HIROSE ELECTRIC CO., LTD.
5-23, OSAKI 5-CHOME, SHINAGAWA-KU, TOKYO, JAPAN

Product Change Notification

■ Product List Business430-18022_FI Series Lock spring shape and dimension change

◆ Lock spring dimension change

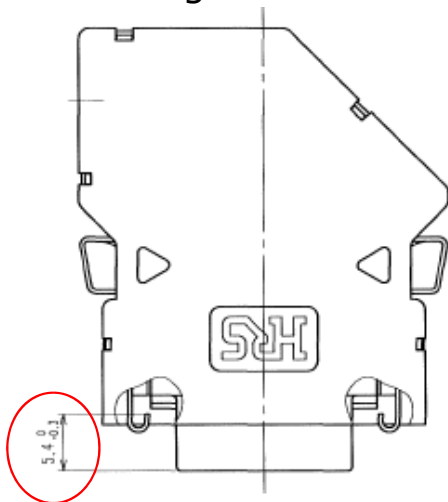
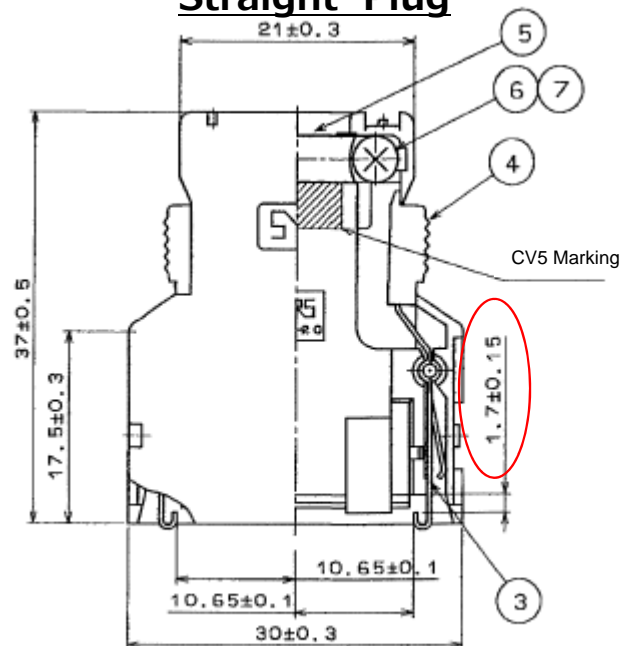
Unify to the setting after assembling the connector unit (setting of the right angle plug) and change the setting dimension to the following.

★ $5.4 + 0 / - 0.3 \Rightarrow \underline{5.07 + 0.275 / - 0.375 (4.695 \sim 5.345)}$

◆ Lock spring tip shape change

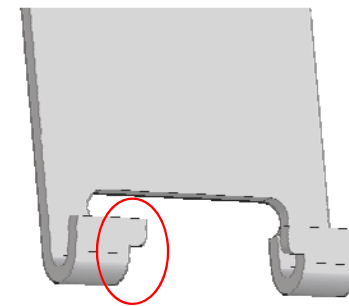
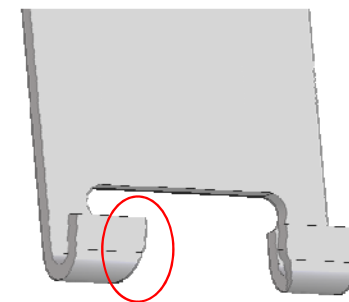
By connecting the straight part gently, insertability is improved.
